Customer Repair Evaluation Report

PD DEAL #: 0000000000 | EVALUATION TECH: | KVA: 3400 | HV: 34500 | LV: 12000Y/6930

Cabinet/Tank Dents/Bends

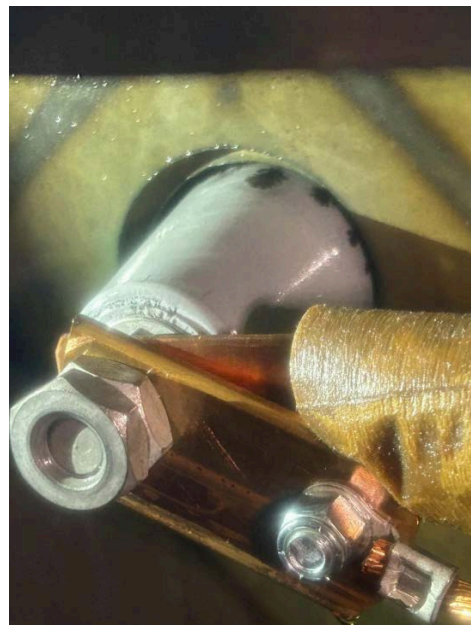
Slight kickplate damage in need of straightening.
